Immingham Green Energy Terminal

9.3 Applicant's Responses to the Examining Authority's First
Written Questions

(Responses to "Q1.4. Design")

Document Reference: TR030008/EXAM/9.3

Appendix 3 - 2205097-RAM-02-LS-SK-C-9000

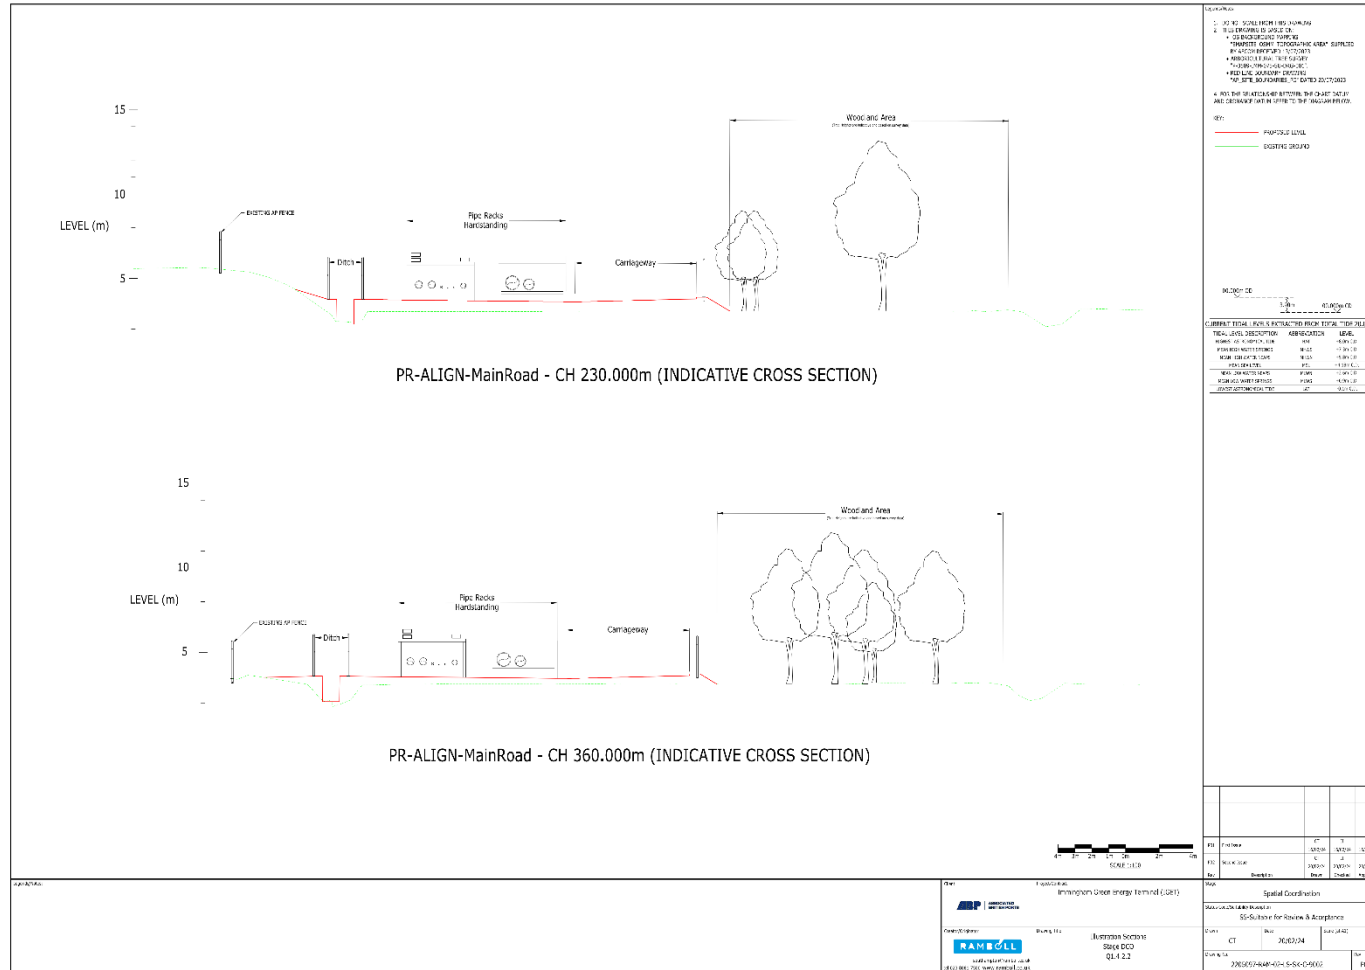
<p>Work No. 2</p> <p>The dDCO indicates maximum heights for built elements and finished ground level [APP- 006, R4, Table 1].</p> <p>a) Given the sensitivity of Work No. 2 that runs through the existing Long Strip Woodland, explain why the maximum finished ground level is indicated as being 5m AOD and where this might occur along the length of Work No.2.</p> <p>b) Provide sections through Long Strip showing the proposed height of the jetty access road in relation to the existing features, natural and manmade. (Continuation of [APP-014 Sheet 3, Section A-A]).</p>	<p>(a) The new ground works are relatively low level with minimal impact on the existing topography. See typical sections in drawing 2205097-RAM-02-LS-SK-C-9002, attached as Appendix 1, to visualise this.</p> <p>The reason for the indication of 5m Above Ordnance Datum ("AOD") was twofold: first, to allow a degree of design development of the roadway and drainage systems and second, it is also recognised that along the boundary with APT's site there is a bank that exists at approximately 5m AOD and landscaping works are likely to be required to facilitate APT's emergency egress re-routing – see section at chainage 230m for an illustration of this. The typical road levels within Long Strip will be between 3.5m AOD and 3.68m AOD, rising in the section closer to Laporte road (outside of Long Strip) to approximately 4.3m AOD.</p> <p>(b) Drawing 2205097-RAM-02-LS-SK-C-9001 (Appendix 2) shows section A-A extended to show the roadway levels, between 3.5m AOD and 3.68m AOD within the Tree Preservation Order ("TPO") area.</p> <p>Drawing 2205097-RAM-02-LS-SK-C-9000 (Appendix 3) has been provided to show where the sections have been taken.</p>

Appendix 5 - 60673509-ACM-HGN-ZZ-DR-CH-0002 [Elevation J]

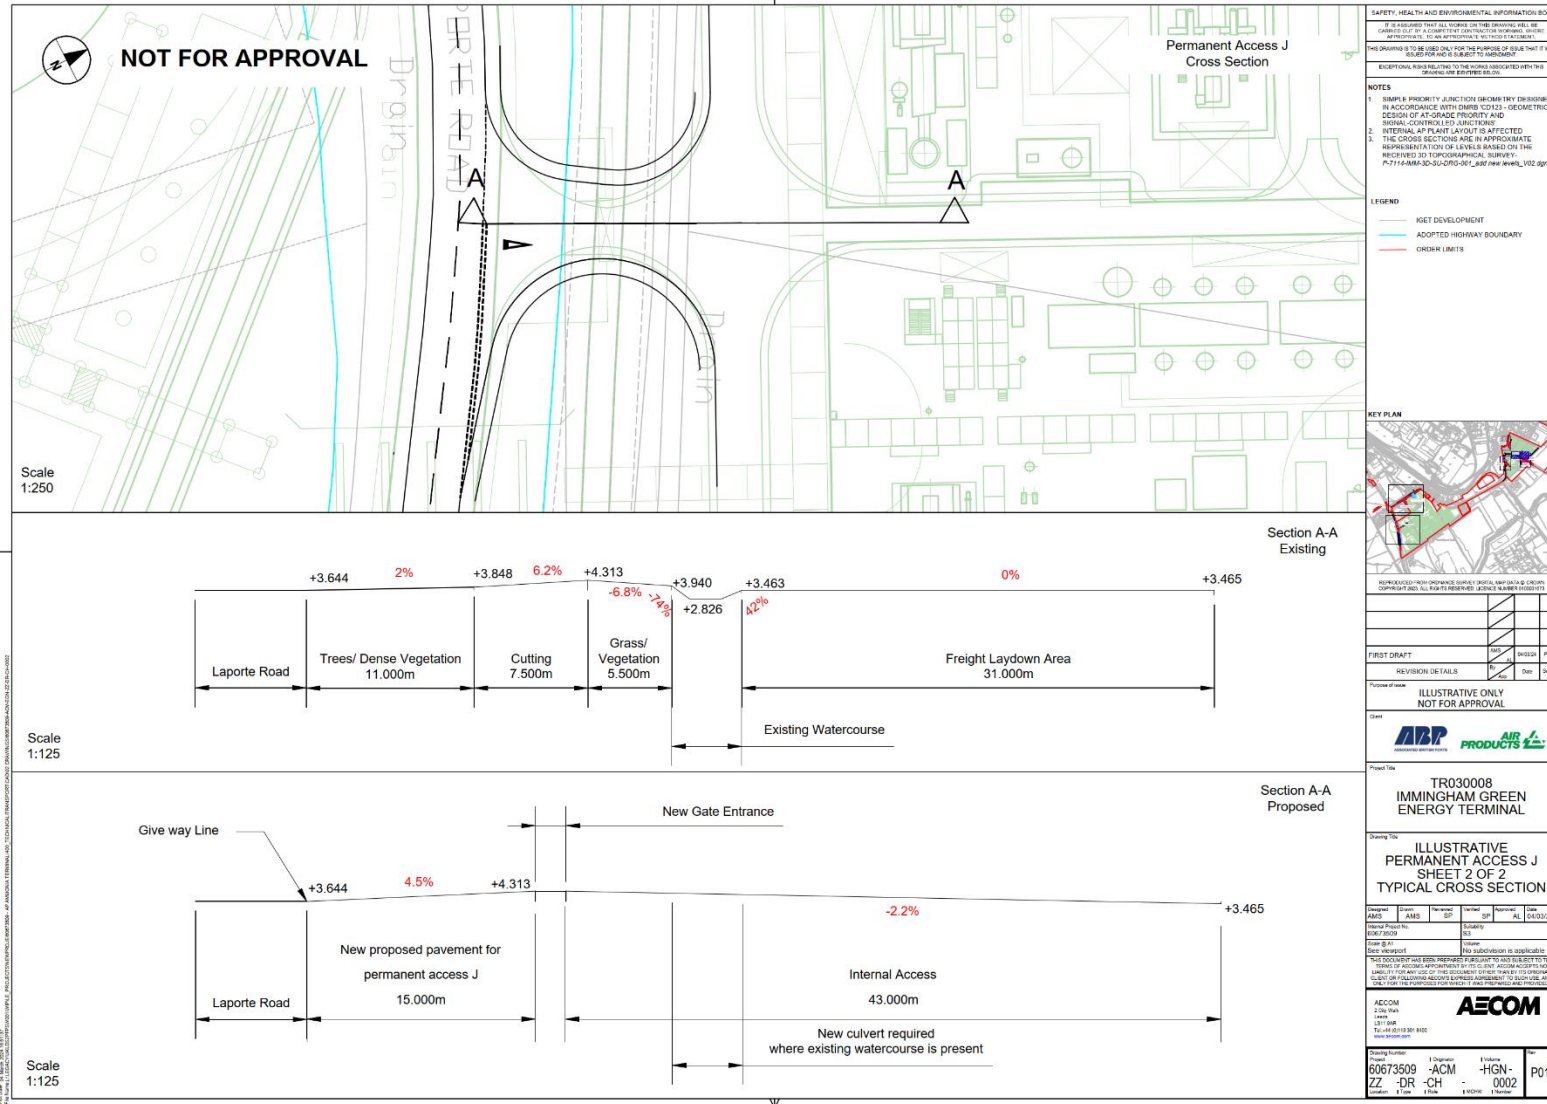
<p>Q1.4.2.3</p>	
<p>Question</p>	<p>Response</p>
<p>Access from Laporte Road</p> <p>Provide contextual elevations of the proposed road accesses from Laporte Road into Work Nos. 2 and 3.</p>	<p>Contextual elevations of Work Nos. 2 and 3 are provided at Appendix 4 and 5 in this document. These plans show cross sections of the proposed arrangement on Laporte Road for Accesses J, K and L, as defined on Sheet 4 of the Street Works and Accesses Plan [APP-016].</p>
<p>Q1.4.2.4</p>
